Issue	Date	Event
A	04.08.22	Issue for Section 4.55

Project
 28 Lockwood Avenue, Belrose

Drawing Title :
 Basement 04 plan

Drawing Title :
 SECTIONS

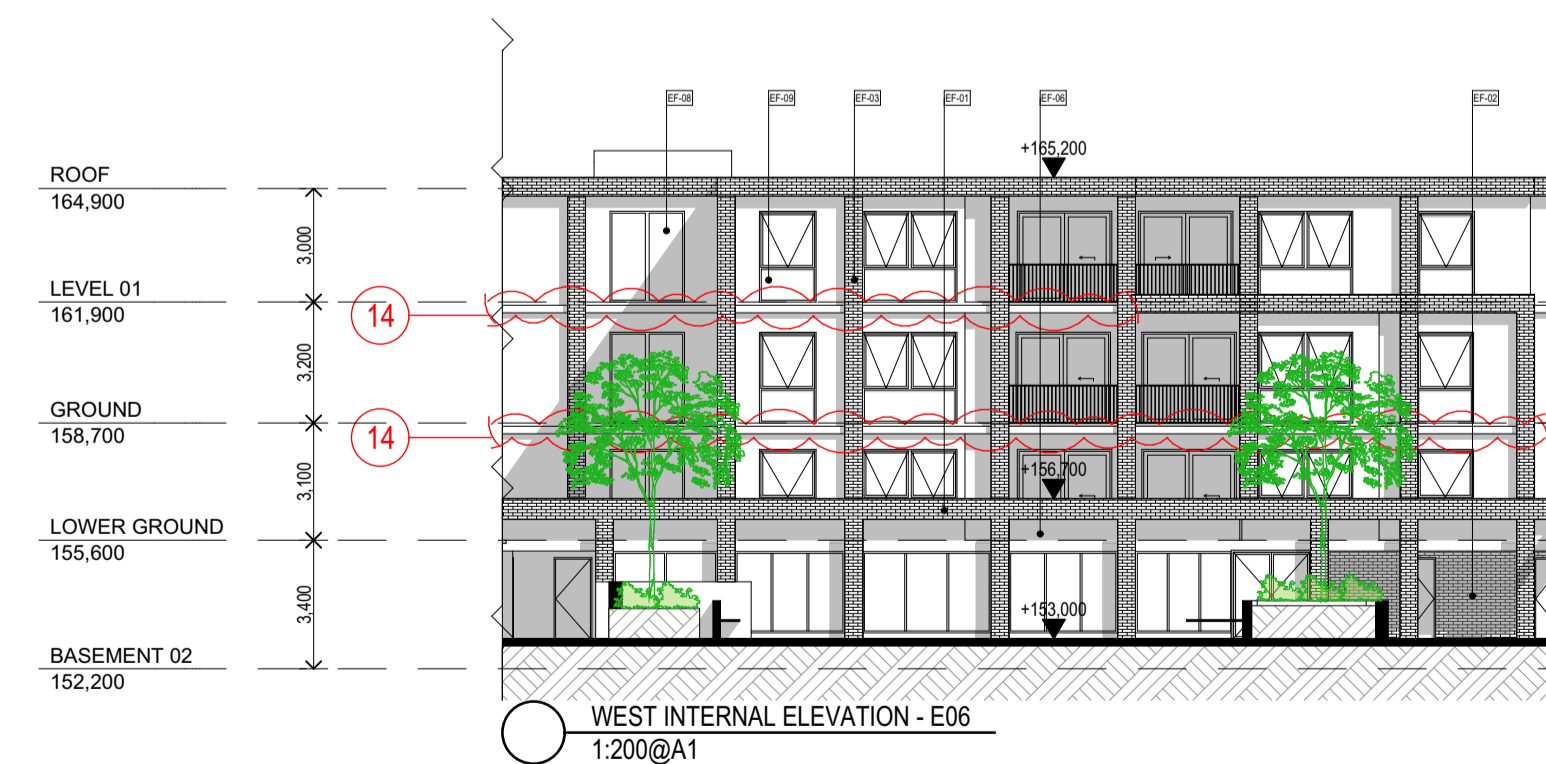
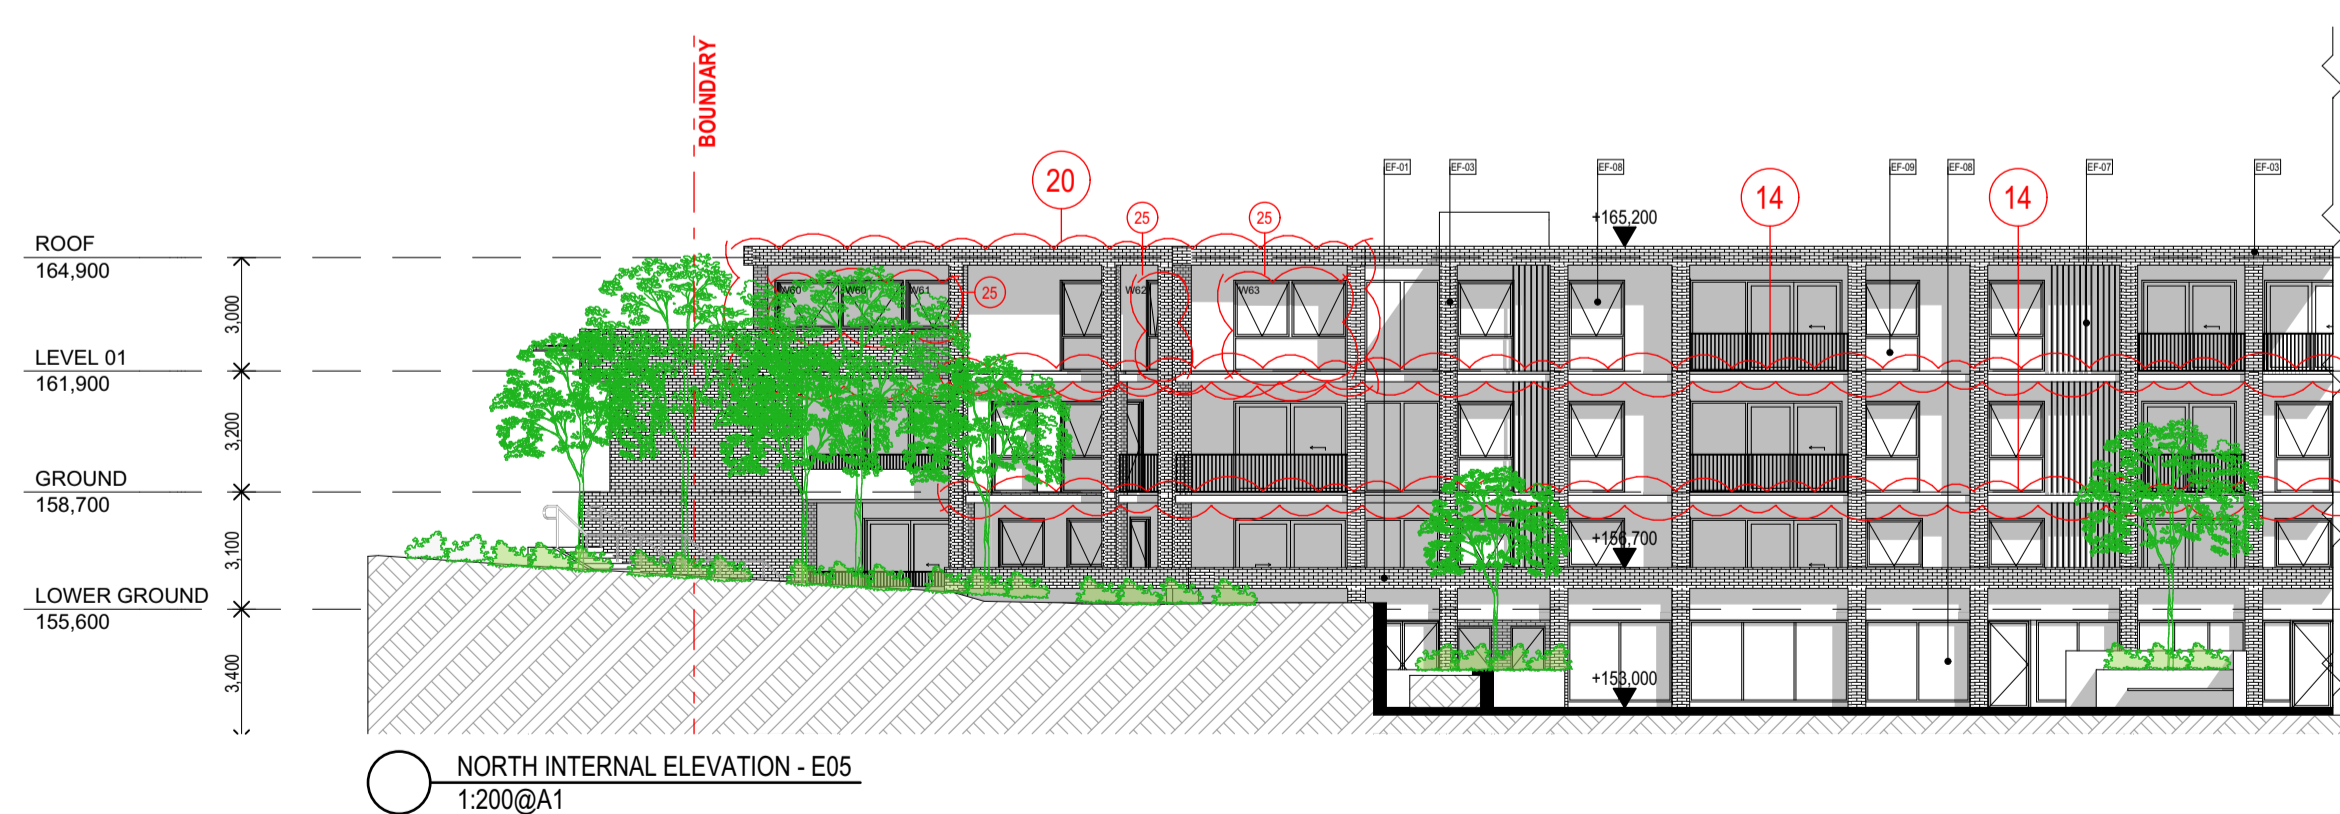
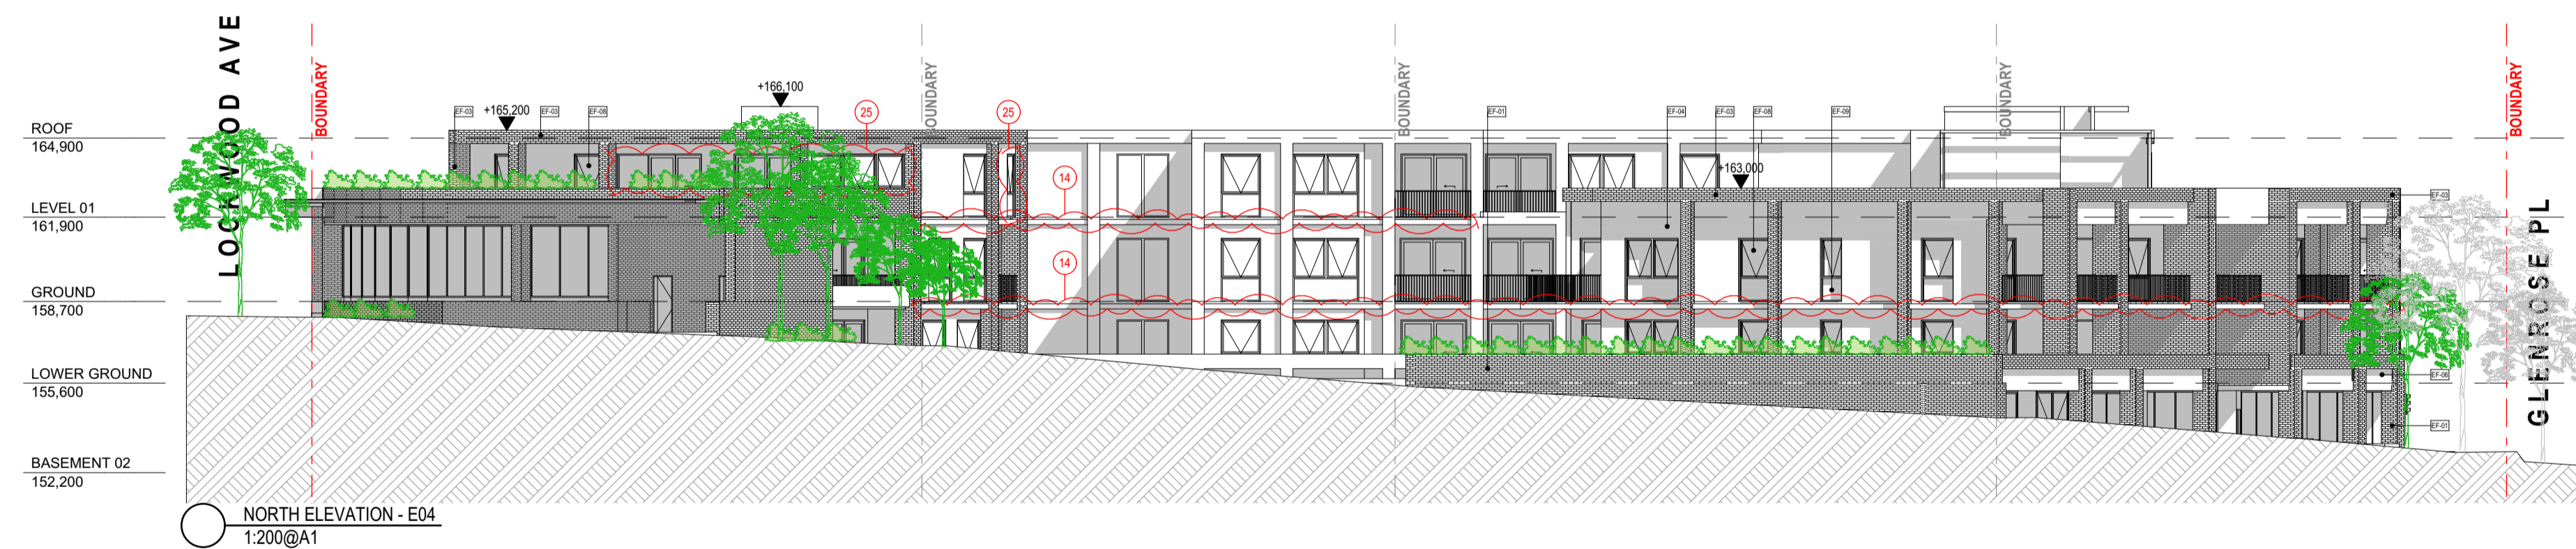
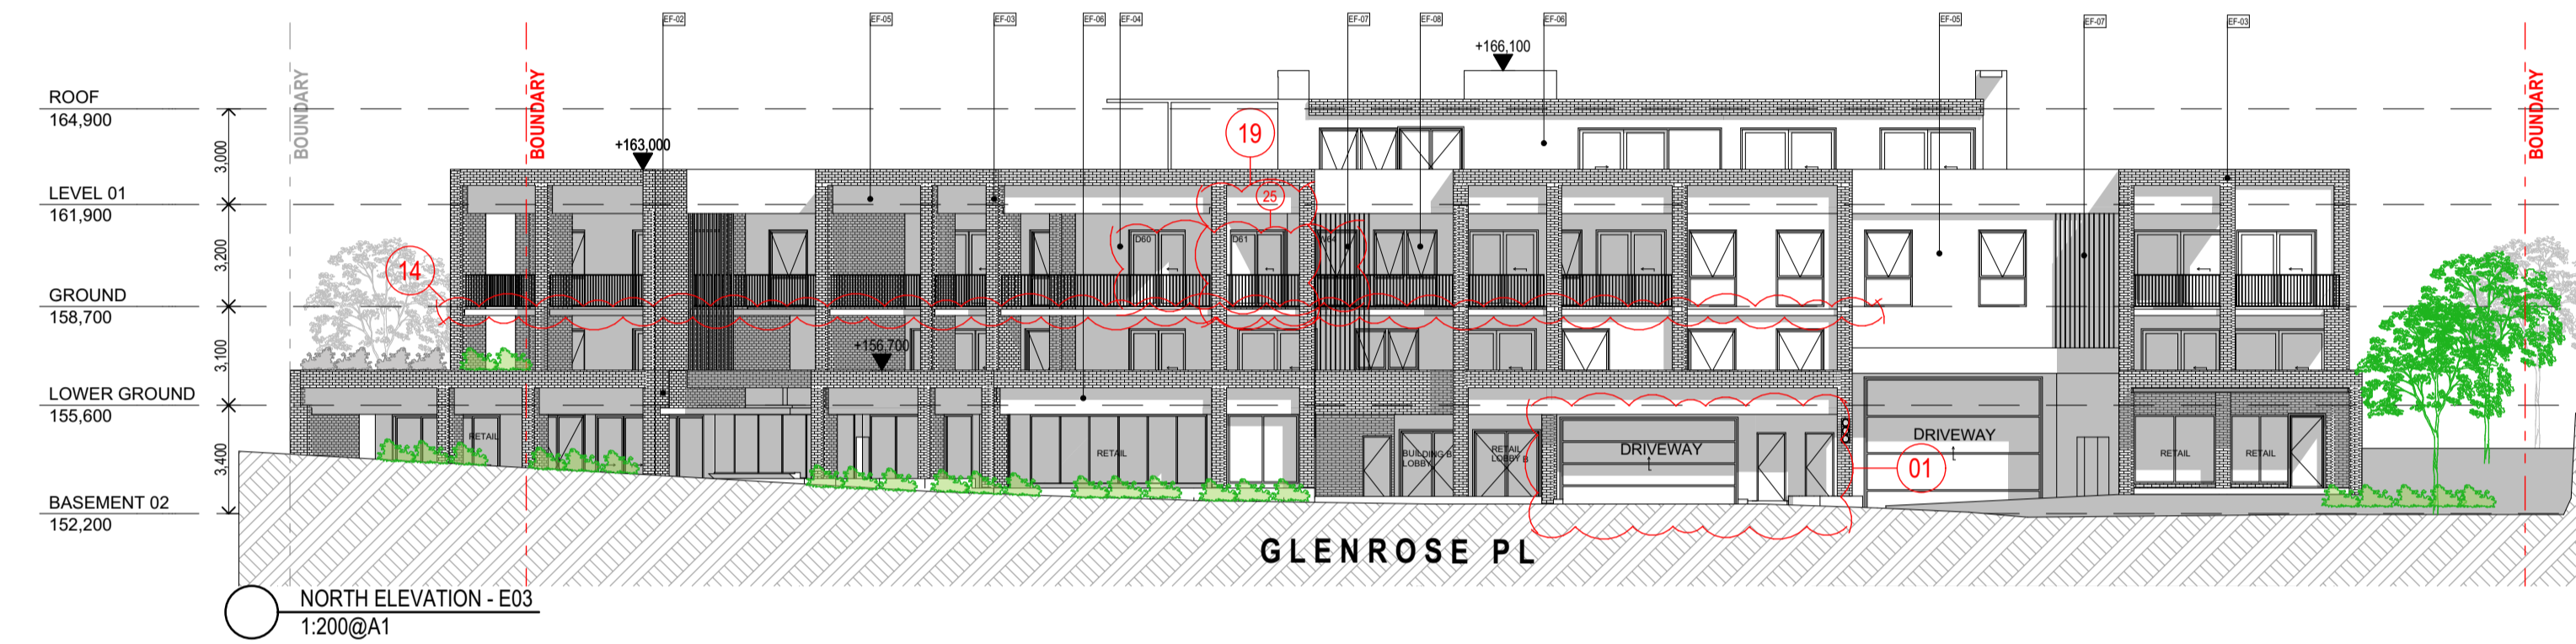
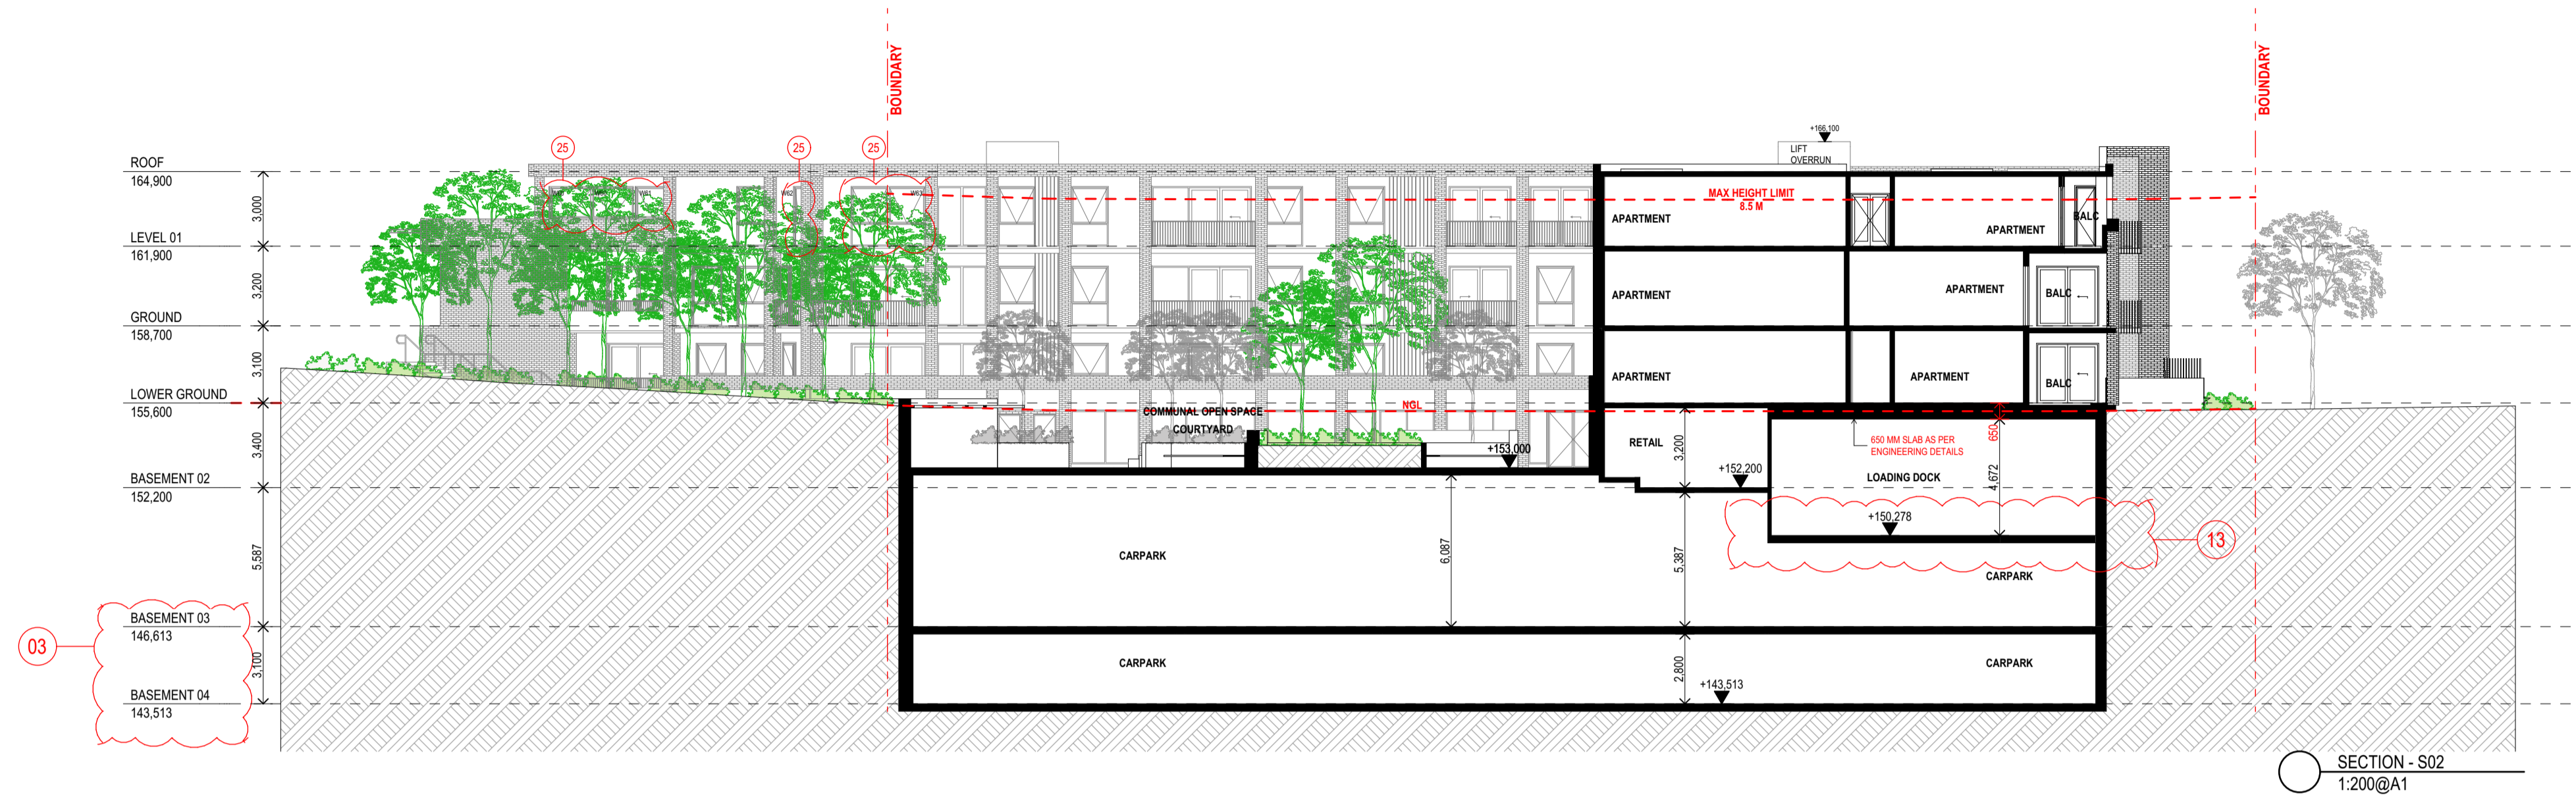
- 1- Entry and exit ramp combined and relocated.
- 2- Traffic flow, car spaces and storage cages rearranged.
- 3- Floor RL lowered.
- 4- EOT and accessible bathroom relocated.

- 5- Fire stairs relocated to comply with NCC.
- 6- Plant and utility rooms rearranged.
- 7- Loading dock entry/exit ramp modified.
- 8- Accessible bathroom provided

- 9- Glenrose pl pedestrian entry ramp and steps modified.
- 10- levels modified.
- 11- Entry to shop number 07 modified.
- 12- Mechanical exhaust shafts located.

- 13- Loading dock RL modified.
- 14- Face brick removed from intermediate exposed slab edges.
- 15- Proposed clubhouse/communal room.
- 16- Fire stairs relocated and minor internal unit rearranged adjacent to the new stair location.

- 17- Glen street pedestrian entry modified for structural rationalisation.
- 18- Electrical switch boards located.
- 19- External wall modified.
- 20- Unit 1.01: East wall relocated, balcony deleted.

- 21- Waste lift is changed to Retail lift and it drops to basement 04.
- 22- The hoist lift in the loading dock is changed to waste lift and it drops to basement 03.

- 23- Roof extended over enclosed balcony.
- 24- Internal layouts modified for more efficient, spatial use and relationship:
LG01, LG02, LG06, LG10, LG12, LG14, LG15, LG18.
G01, G02, G05, G09, G13, G15, G16.
L1.02, L1.05, L1.08, L1.12, L1.13, L1.14
The amendments for the following units are subject to section 4.55 application:
LG03, LG05, LG07, LG08, LG09, LG11, LG13, LG17, G03, G06, G08, G10, G11, G12, G14, L1.01, L1.03, L1.04, L1.09, L1.11.

- 25- New aluminum windows and doors.
